July 8, 2013
PLANNING COMMISSION HEARING
“OTHER BUSINESS”
OPEN SPACE REVIEWS AND APPROVALS

AGENDA ITEM # 1 (OSC 13-02)

PETITION NO: OSC 13-02

PLANNING DIVISION COMMENTS

Figure 5 Location of Civil War Earthworks Observed in the Project Area

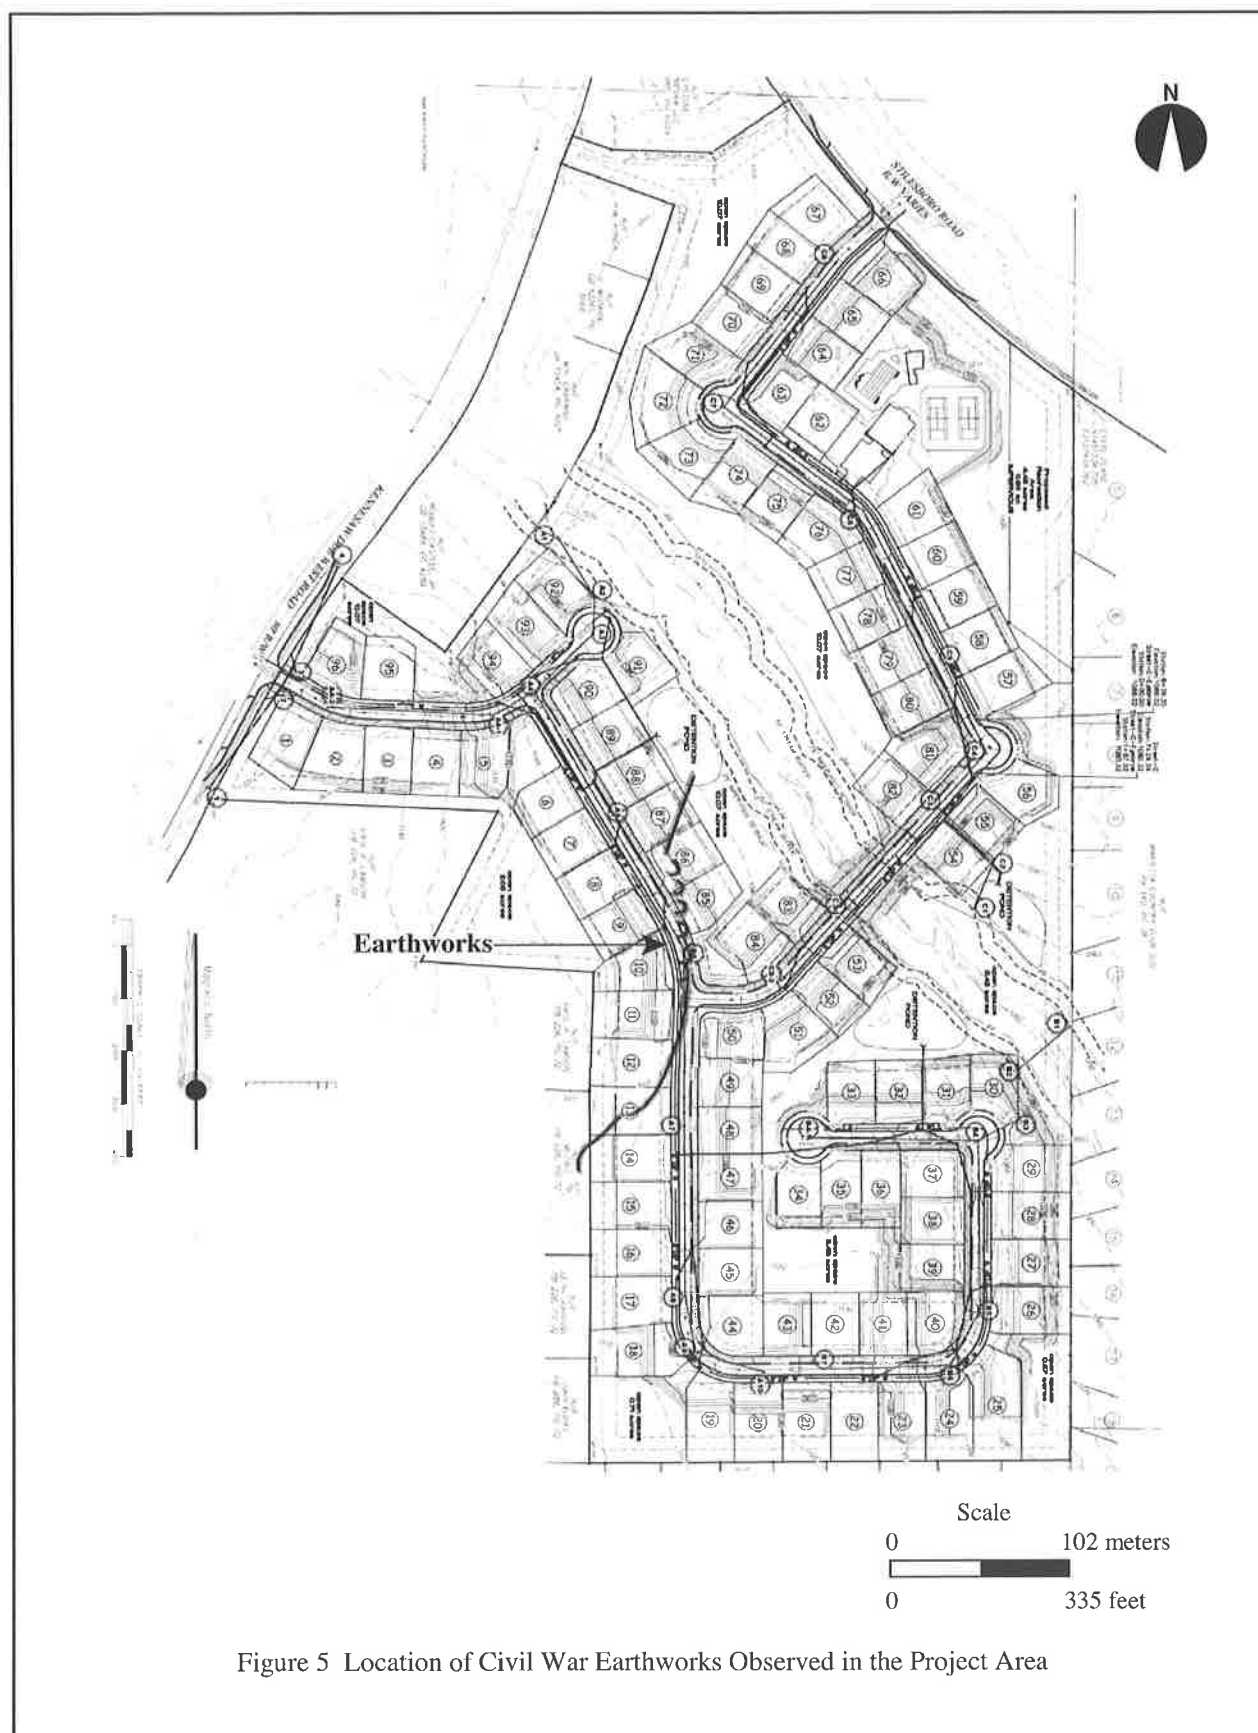
- In order to preserve all or part of the trench line and redoubts, staff recommends the reworking of the site plan to move lots to new locations and/or the removal of lots to accommodate trench line.
- Staff recommends a 25-foot buffer around all sides of any preserved trench or redoubt.
- Staff recommends that all preserved trenches or redoubts be fenced at the edge of the 25-foot buffer.
- Staff recommends a historic marker/interpretative signage be placed on the property detailing the history of the trenches and their significance.
- The preserved areas should be made part of the conservation easement and all maintenance will be the responsibility of any Homeowner's Association.
- Staff recommends mitigation payment of \$50,000 to Cobb County that will be set aside for preservation of other historic assets in unincorporated Cobb County.

1. Lots 82 and 92 should be completely above Floodplain
2. Civil War earthworks have been observed on site. Please provide a plan that depicts location, orientation and type of earthworks that exist on property and include the historic area to be protected within the required Open Space unless other measures have been agreed upon.
